August 28, 2013

Anthony Fracasso, Senior Vice President  
MassDevelopment  
160 Federal Street, 7<sup>th</sup> Floor  
Boston, MA 02110

Re: C. 40B Project Eligibility Application;  
Project: The Residences of South Brookline  
Location: Independence Drive, Brookline, MA  
Applicant: Chestnut Hill Realty

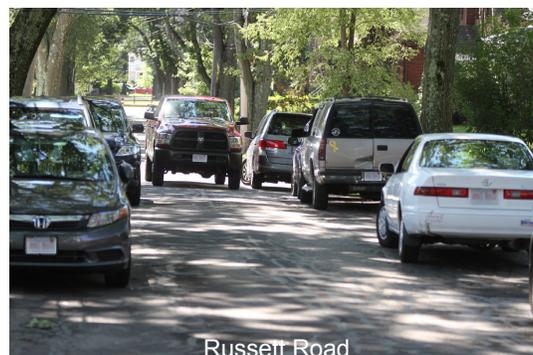
- D.** Most of the traffic from Hancock Village East (purple arrows) will be routed from Asheville onto Russett Road, a narrow (24’ wide) neighborhood road that cannot handle this volume of traffic.

**Fig. 4. Russett Road is too narrow to accommodate significant traffic.** Most of the traffic from the east side of the proposed project will be routed onto Russett Road via Asheville (a short feeder road). Russett is a narrow neighborhood road that is too small to accommodate this traffic safely. The other roads off of Asheville are similarly narrow and overburdened. A truck can barely navigate down Russett when cars are parked on the sides of the road, as is frequently the case. Residents indicate that their side mirrors are frequently broken after parking on this road.

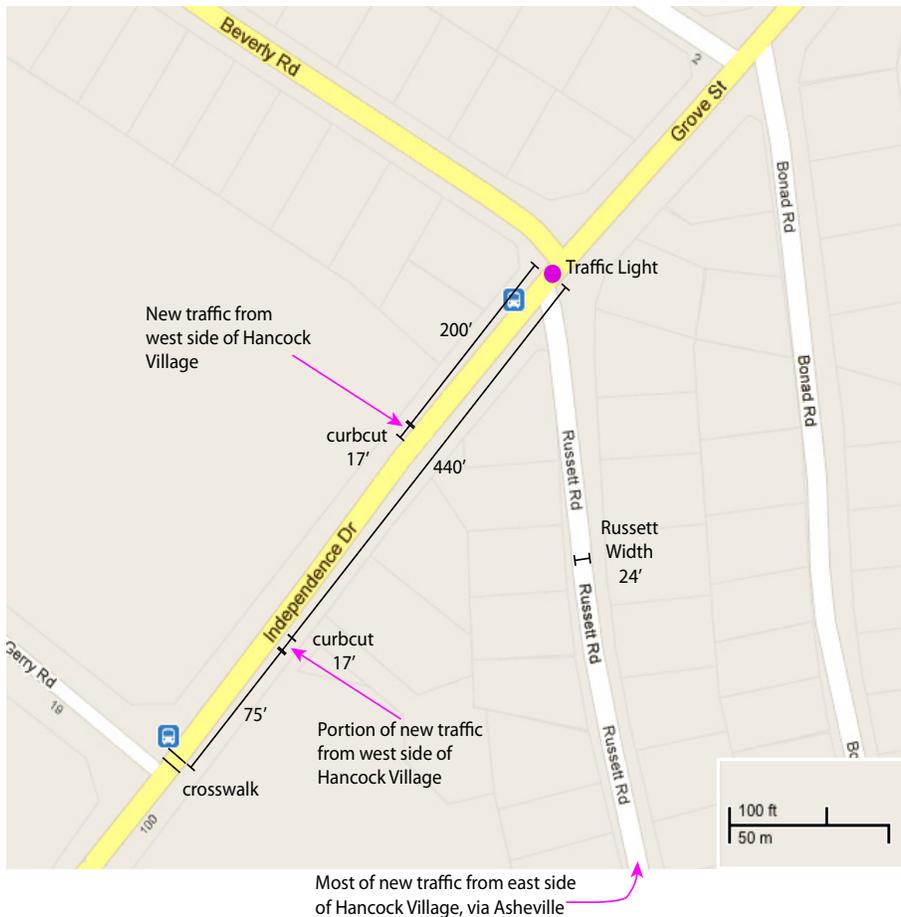
**Fig. 5. Beverly-Russett Map.** The map shows the configuration of the intersection of Beverly, Russett, and Independence/Grove. Curbcuts indicate locations of planned driveways. Most of the traffic will enter Russett, a narrow two-way neighborhood road. Independence/Grove is a high speed four lane road. The project will add two additional entrances onto Independence within a short distance, further complicating this intersection.

intersections (Fig. 5). The Beverly/Russett/Independence intersection is awkward because Russett enters at a sharp angle. The proposal will add a road from the West side, entering Independence only 200 ft. from the intersection. From the East side, some of the traffic will enter Independence about 400 ft. from the intersection. Beverly Road carries substantial traffic related to Baker School and is sufficiently narrow that for the last several years it has been converted to a one way road over the winter.
